OFFICE OF
FRESNO
IRRIGATION DISTRICT

May 16, 2012

RE: Review of 30% High Speed Rail Plans for Segment 1A
(Veteran's Boulevard to Stanislaus Street)

FID Facilities: Herndon Canal No. 39 Lisenby No. 45, Victoria No. 42, Victoria Colony No. 43, Tracy No. 44, Cole West Branch No. 40, Cole South Branch No. 40, and Dry Creek No. 75.

40_UTILITY PLAN - SIERRA SUBDIVISION - UT-C4019.dgn

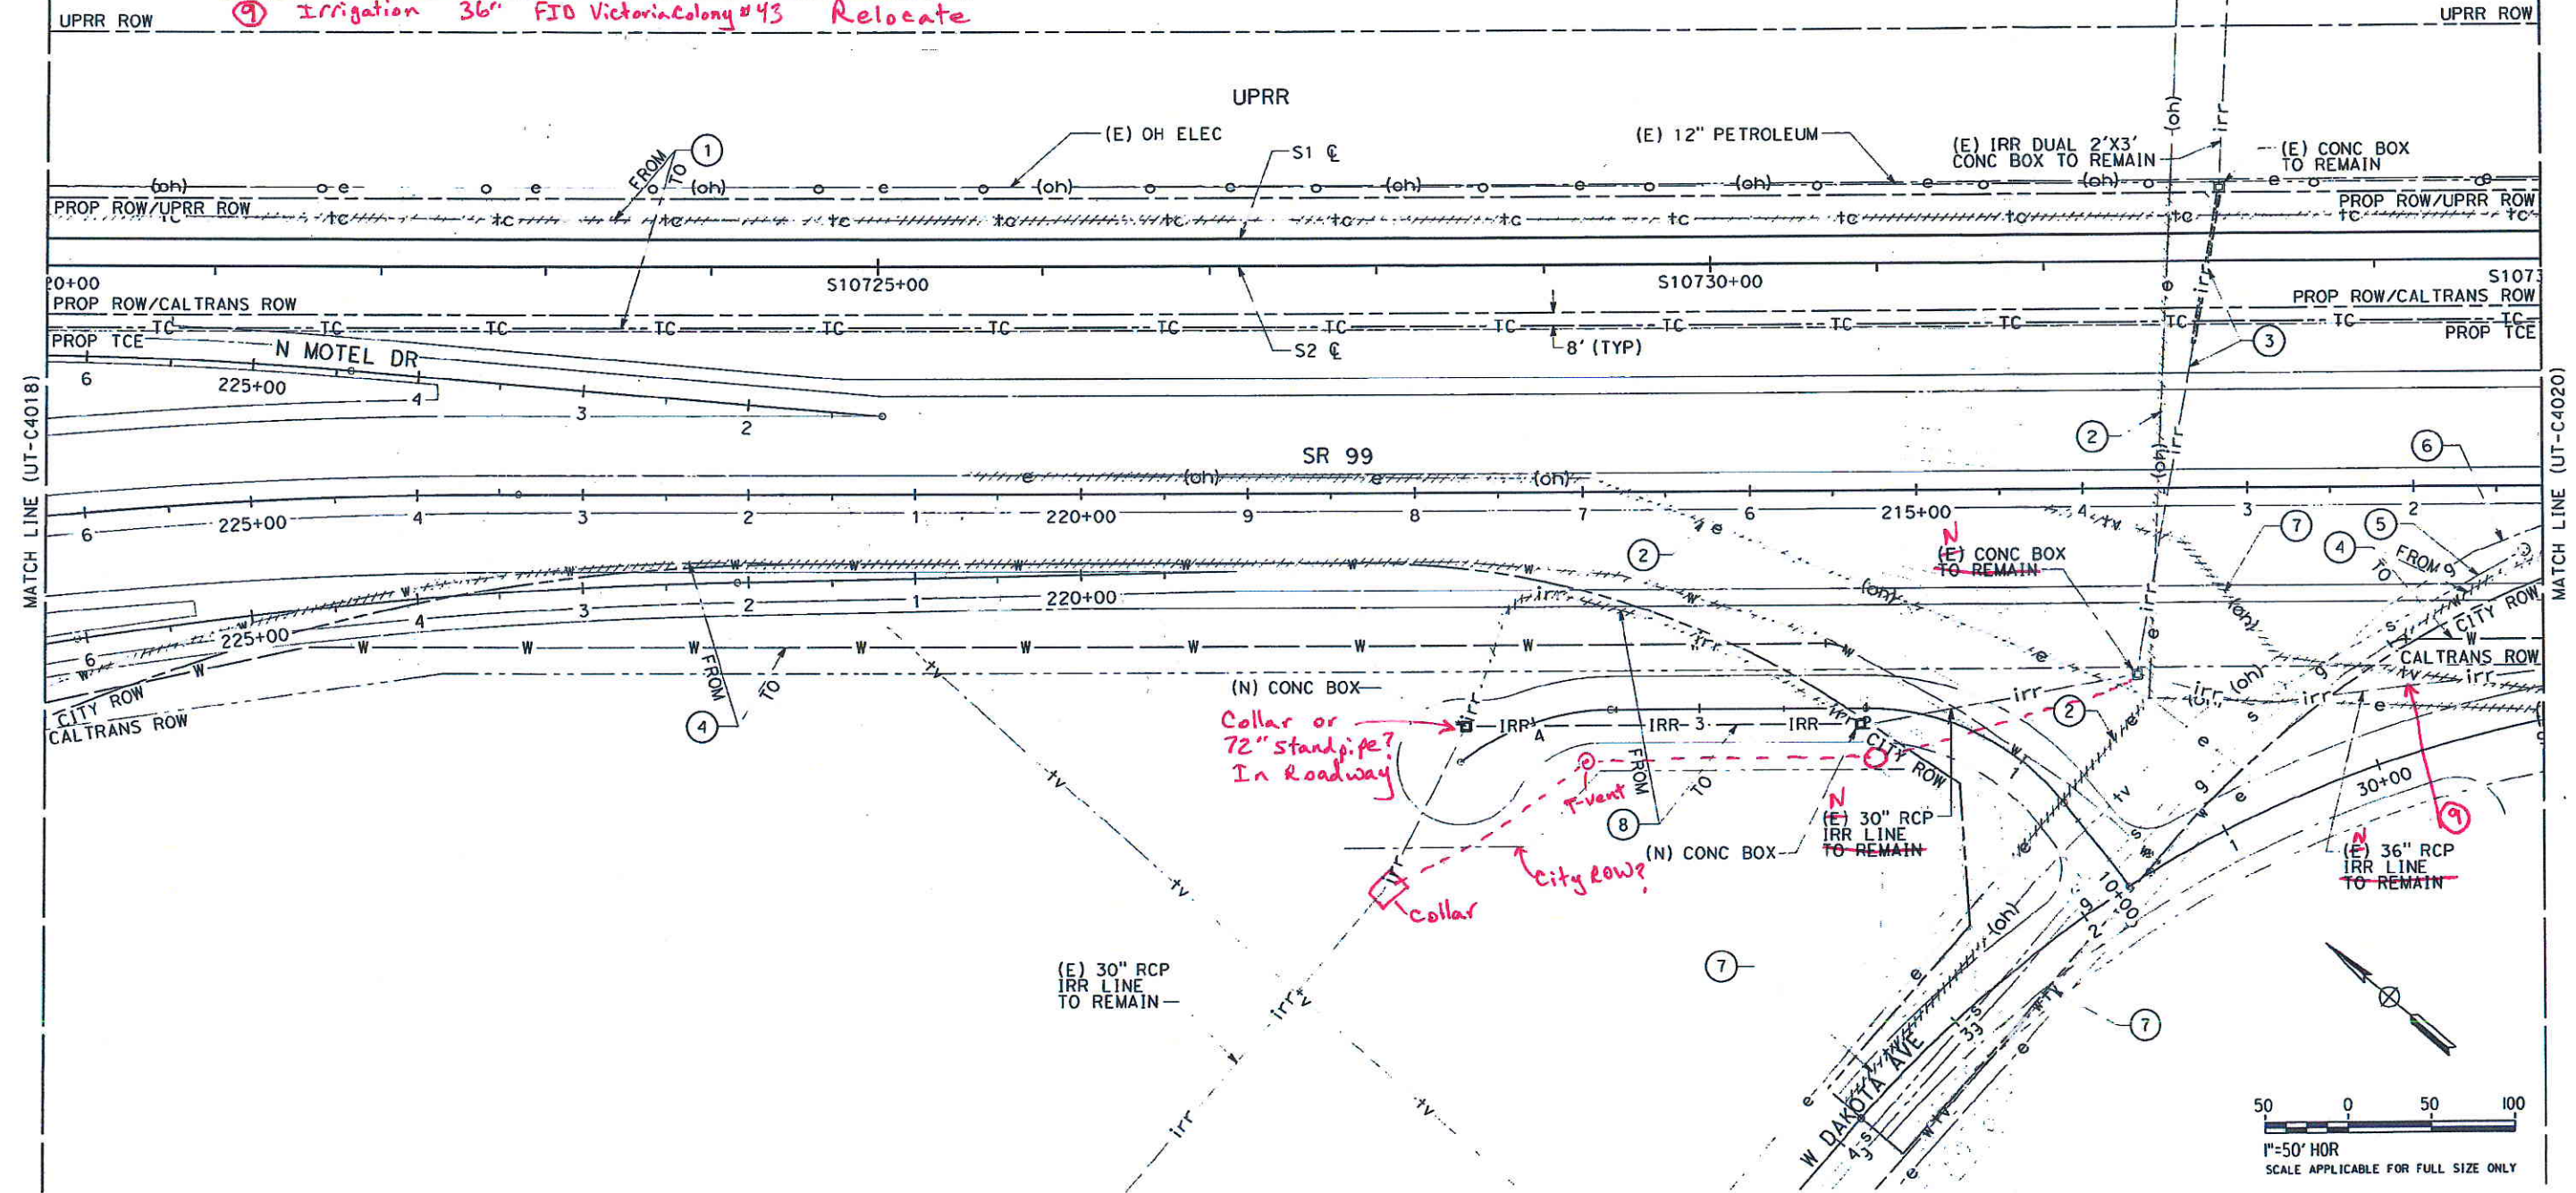
- The existing box structure on the west side of Highway 99 shall be replaced in accordance with FID standards. A possible relocation is located on a markup provided. A detail for this structure shall be included in the plans. The location of this structure shall be confirmed to be accessible to FID at all times. In addition, this box is a diversion box and headgate structure for both the Victoria Colony No. 43 and the Tracy No. 44 and will therefore require two gates at this location.

- The casing shall extend across the CHSRA's full right of way width. More detail is needed to understand the location of construction/receiving pits and the extent of construction to determine the work within the UPRR right of way. The box structure on the upstream side (within the UPRR right of way) will likely need to be replaced with a 60-inch standpipe or similar structure.

- Add the name of FID's facility to all appropriate plan sheets, including the Utility Information tables on the Utilities sheets.
- Plan sheets reviewed include CV-R1009-R99, CV-G1010-R99, CV-G1009-R99, CV-G1017-R99, CV-G1007, CV-R1017-R99, UT-C4019, UT-C4020, C4033. Please identify any other sheets that cover the area of this FID facility.

CONTRACT NO.
DRAWING NO.
UT-C4038
SCALE
AS SHOWN
SHEET NO.

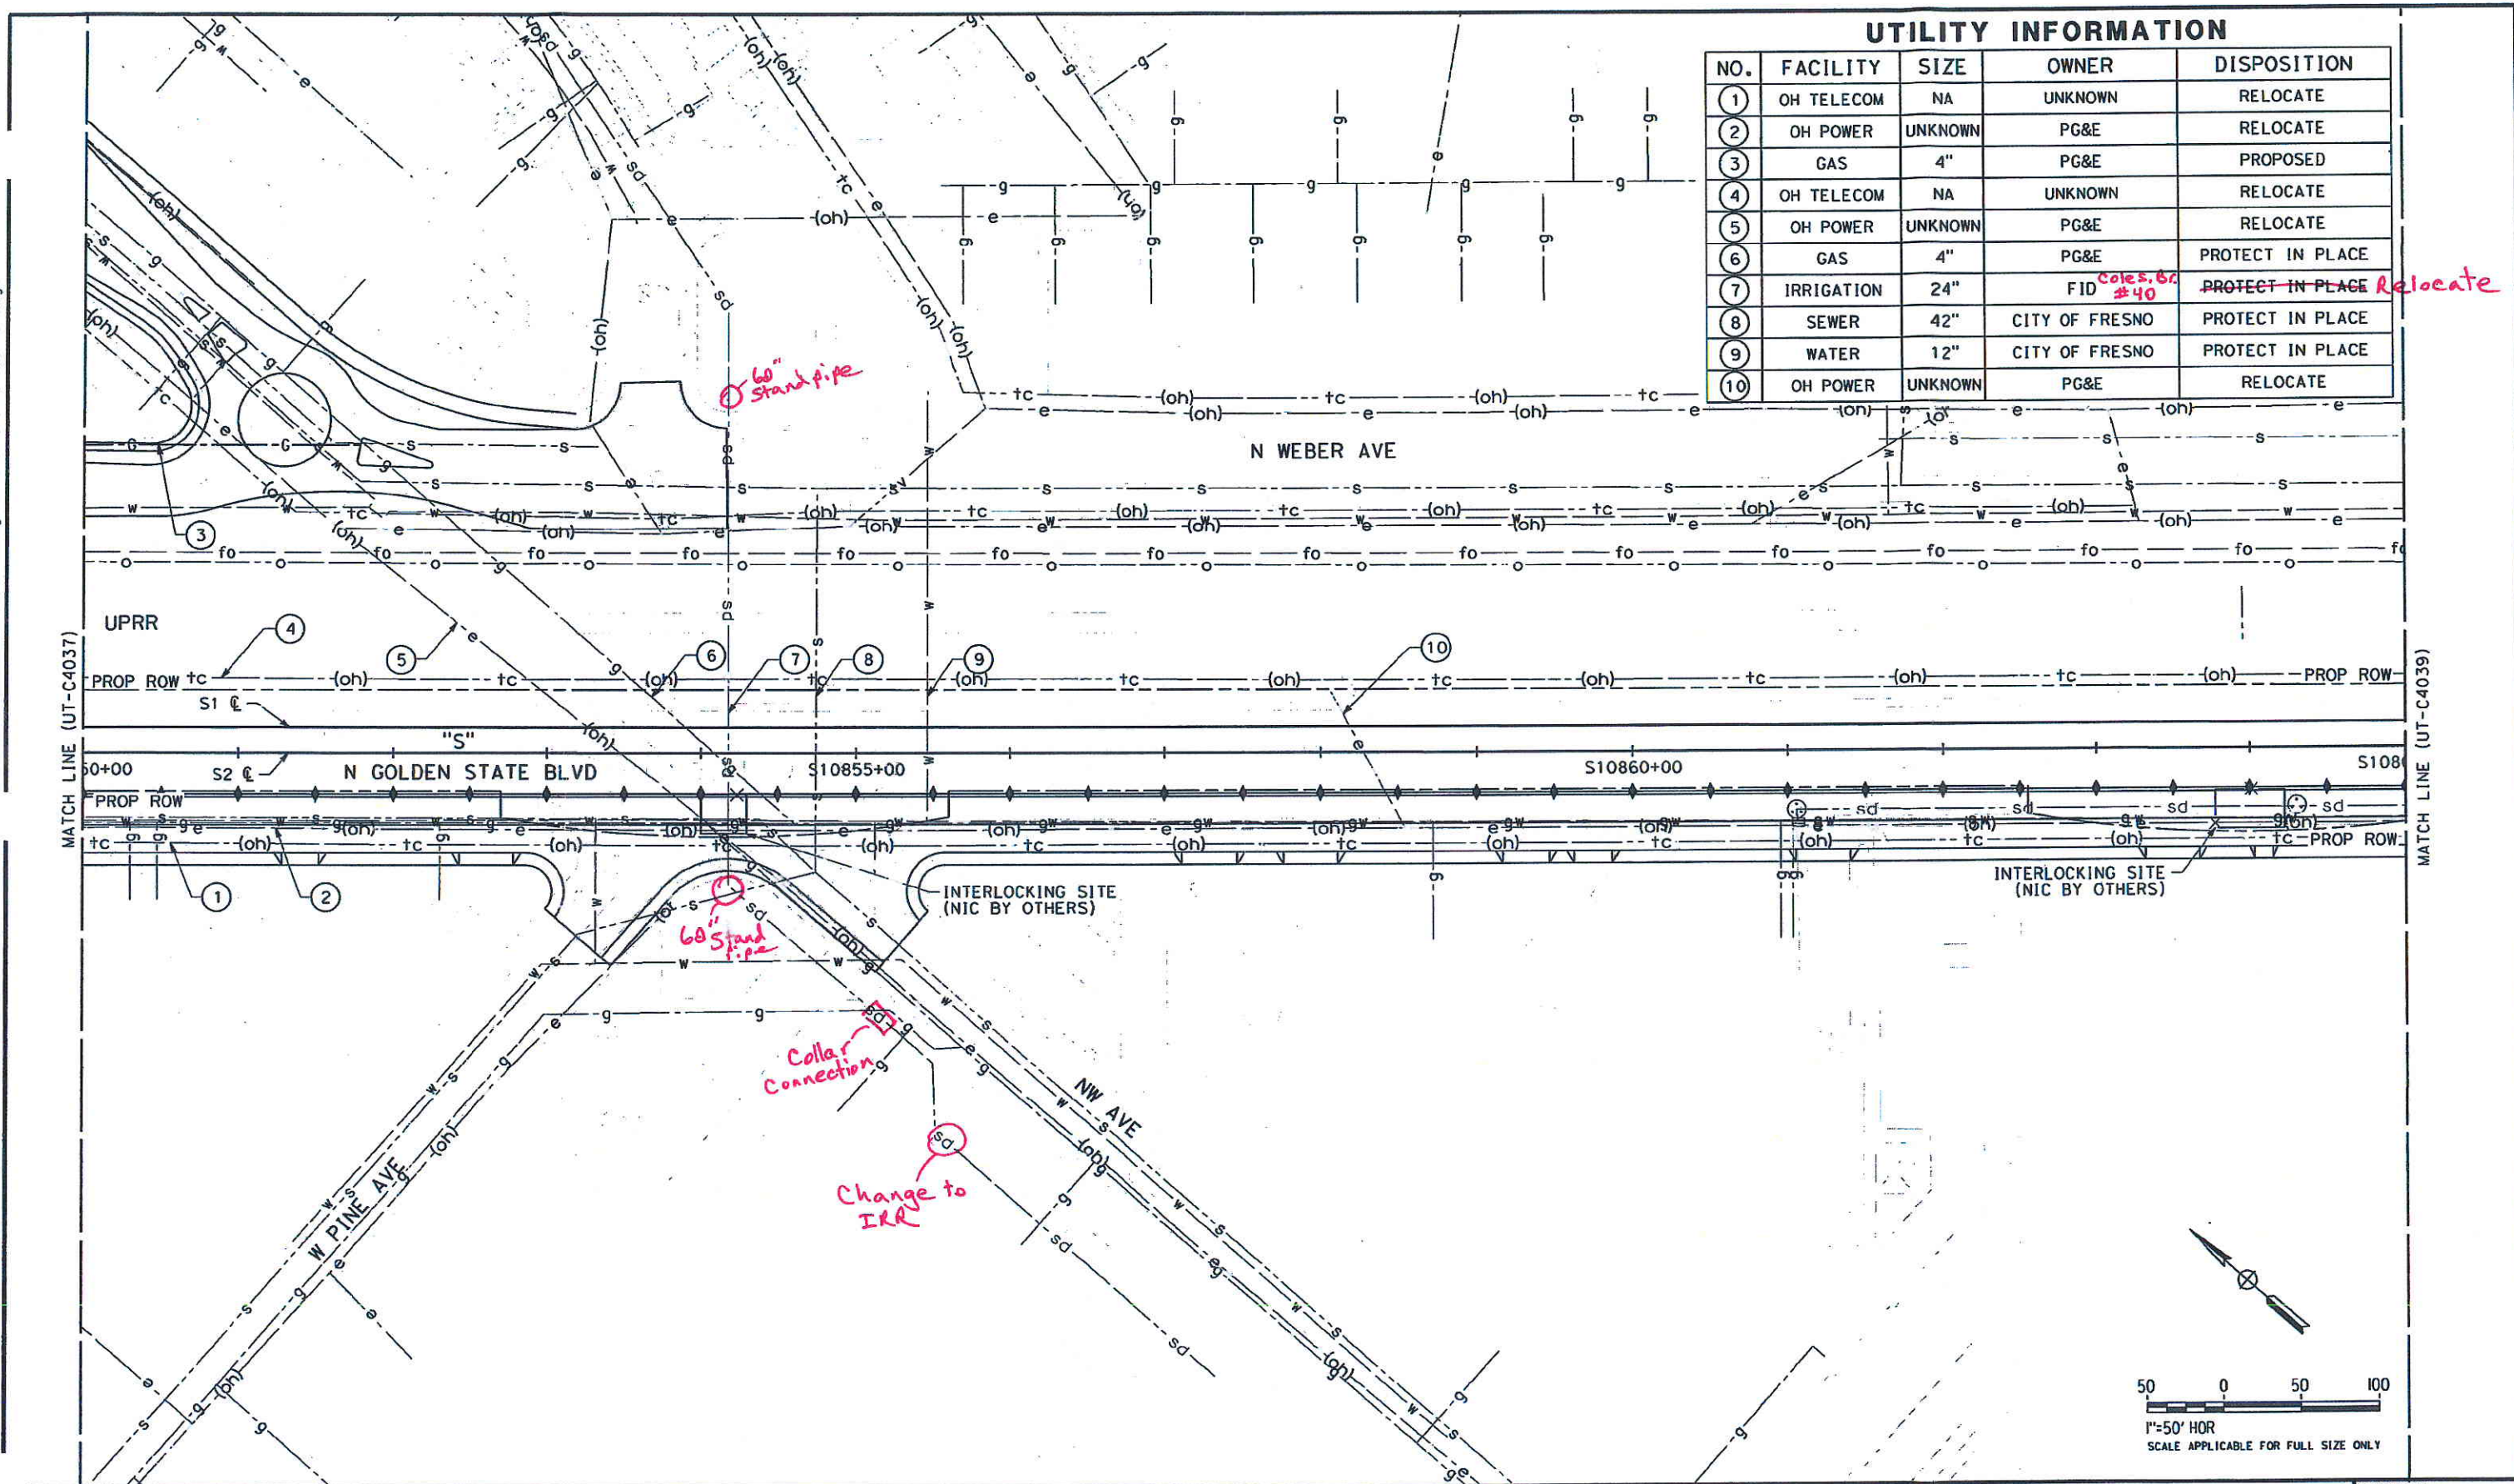
- FID's pipeline is misidentified as a storm drain facility. Correct the label (and associated linetype) on sheet UT-C4038 from "SD" to "IRR".
- A 60-inch diameter standpipe shall be constructed on both sides of rights-of-way limits for Golden State Boulevard and the CHSR. The standpipes shall be in accordance with FID standards and include a metal cover and access hatch. A detail of the standpipe shall be included in the plans. Refer to the attached details.

- Add the name of FID's facility to all appropriate plan sheets, including the Utility Information tables on the Utilities sheets.
- Plan sheets reviewed include UT-C4038. Please identify any other sheets that cover the area of this FID facility.

CONTRACT NO.
DRAWING NO. UT-C4015
SCALE AS SHOWN
SHEET NO.

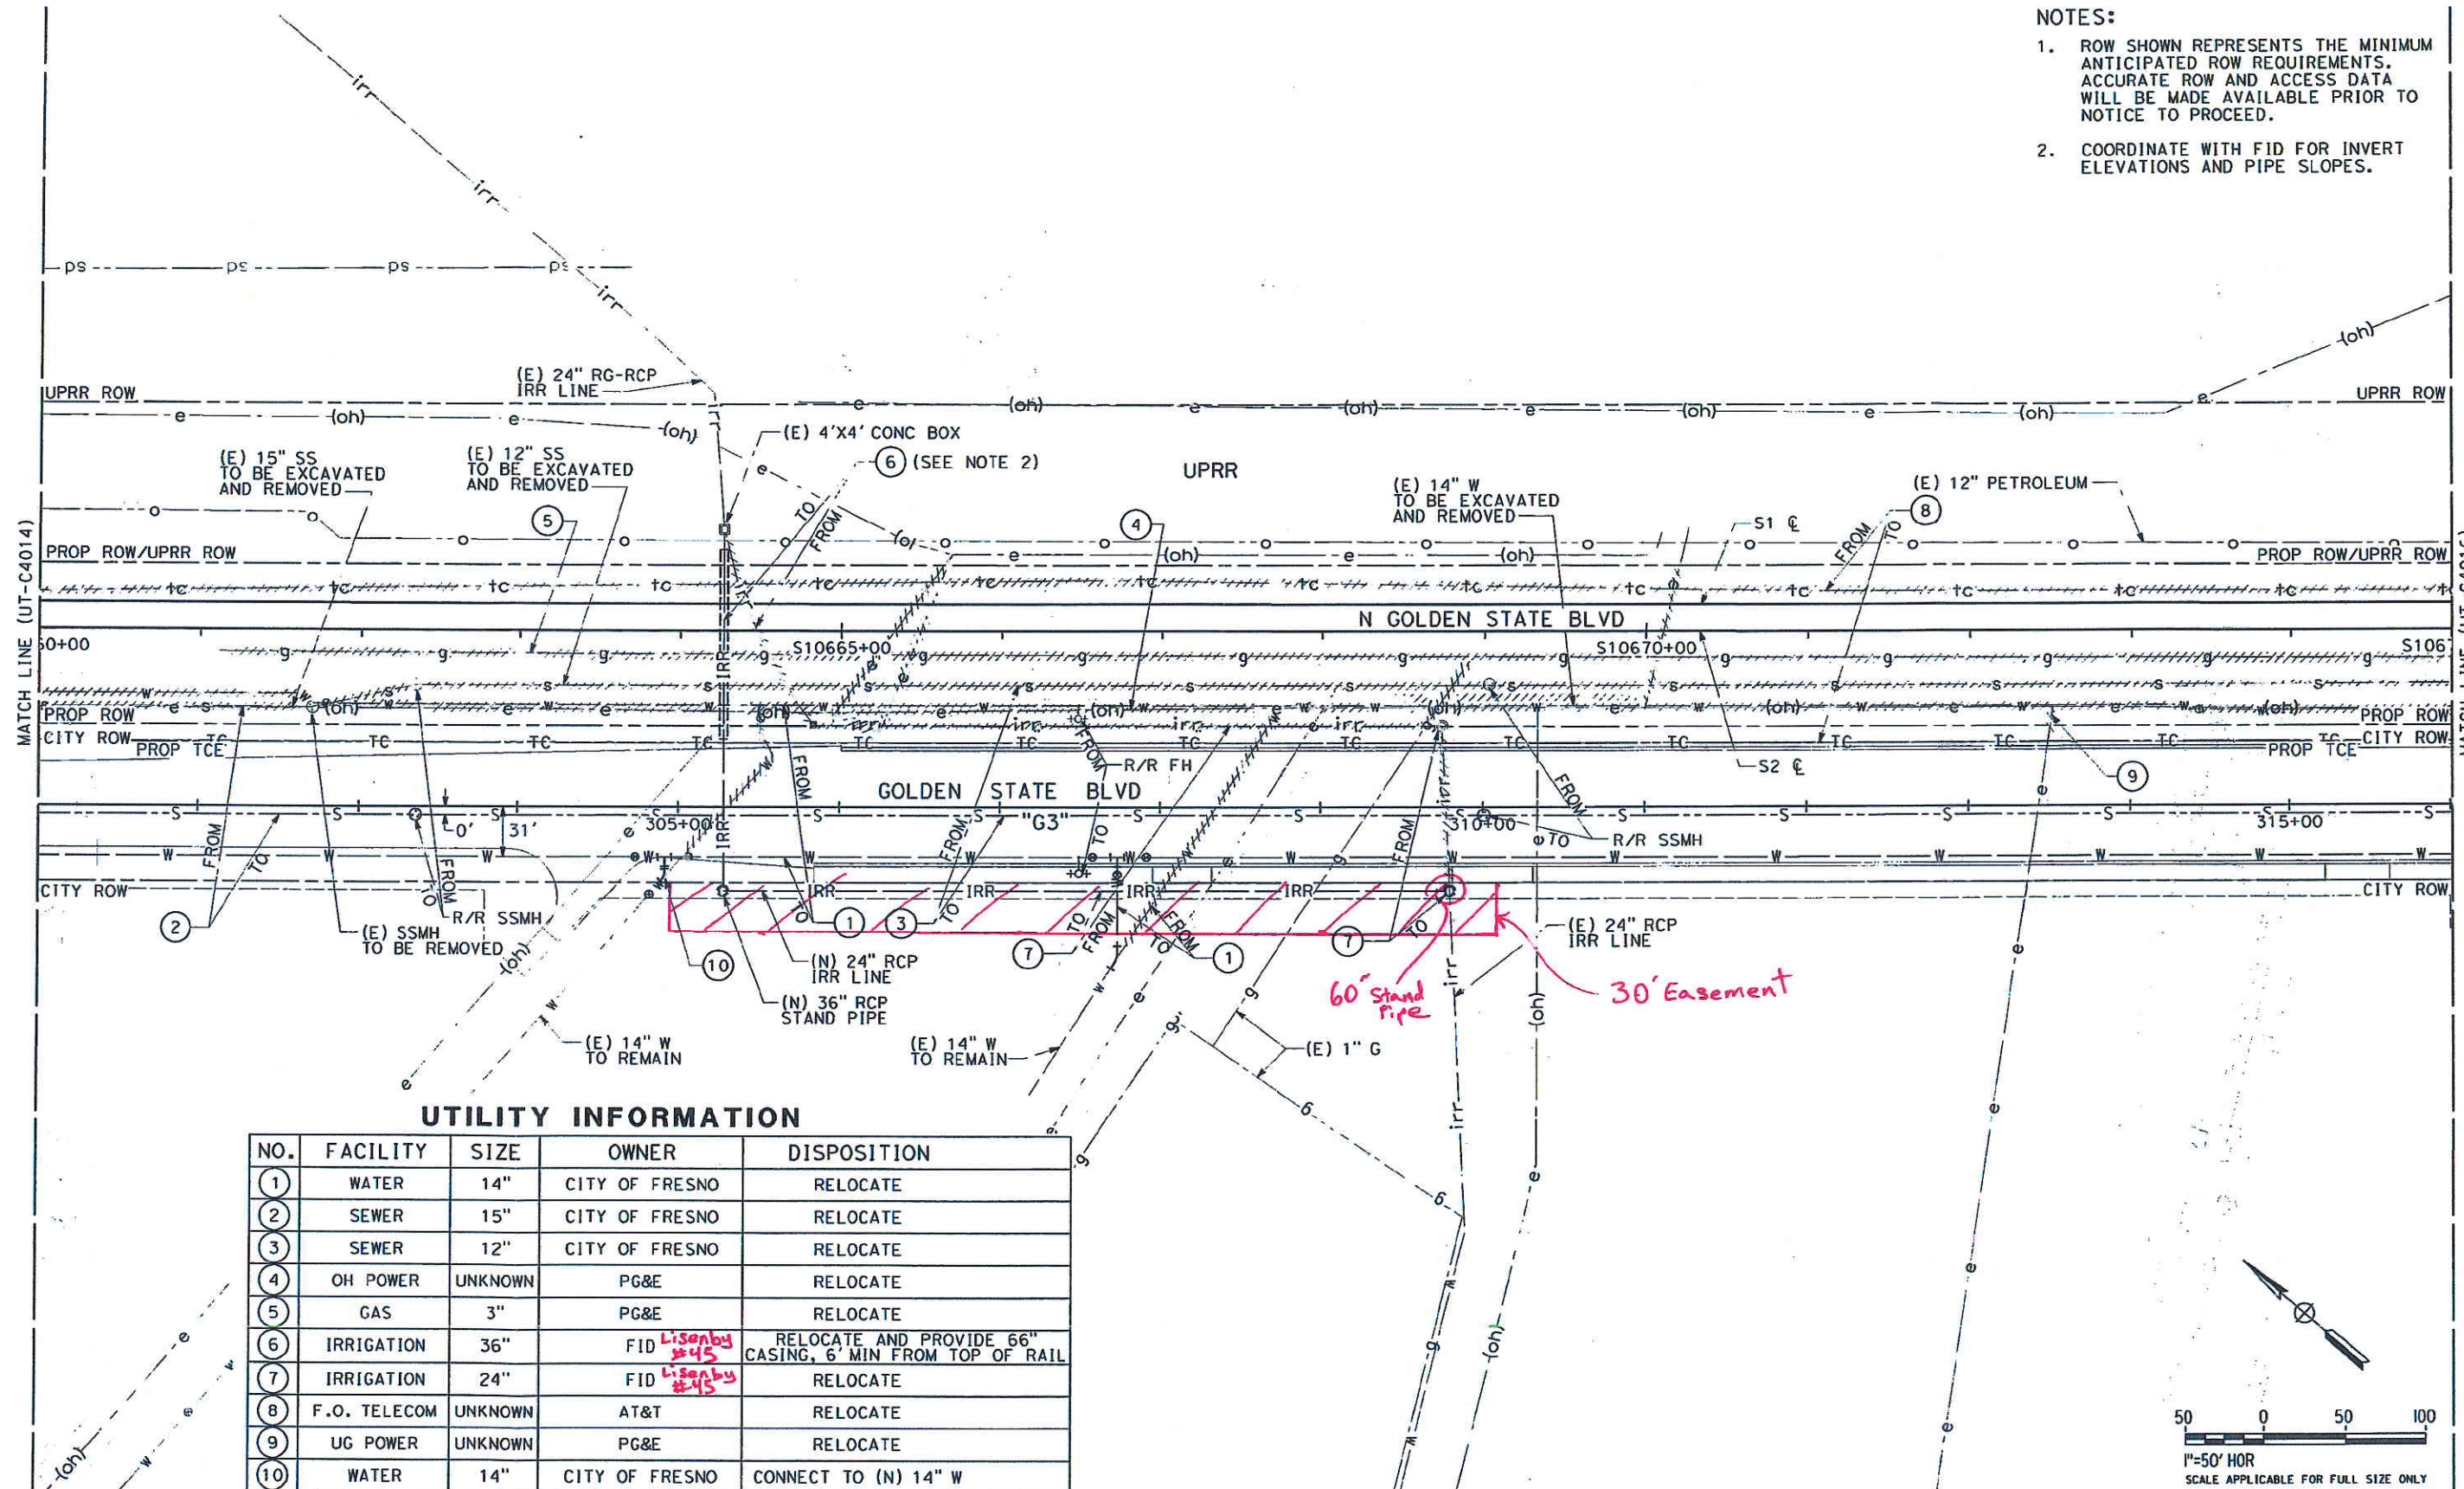
- At the two locations with 90-degree angles in the pipeline alignment, a 60-inch diameter concrete standpipe shall be included in accordance with FID standards including a metal cover and access hatch in each. Refer to FID standard detail 26B.

- The casing shall extend across the CHSRA's full right of way width. More detail is needed to understand the location of construction/receiving pits and the extent of construction to determine the work within the UPRR right of way. The existing

- A 30-foot wide exclusive pipeline easement will be required for the new pipeline.
- Add the name of FID's facility to all appropriate plan sheets, including the Utility Information tables on the Utilities sheets.
- Plan sheets reviewed include CV-G1009-GSB, CV-R1009-GSB, CV-G1010-R99, UT-C4015. Please identify any other sheets that cover the area of this FID facility.
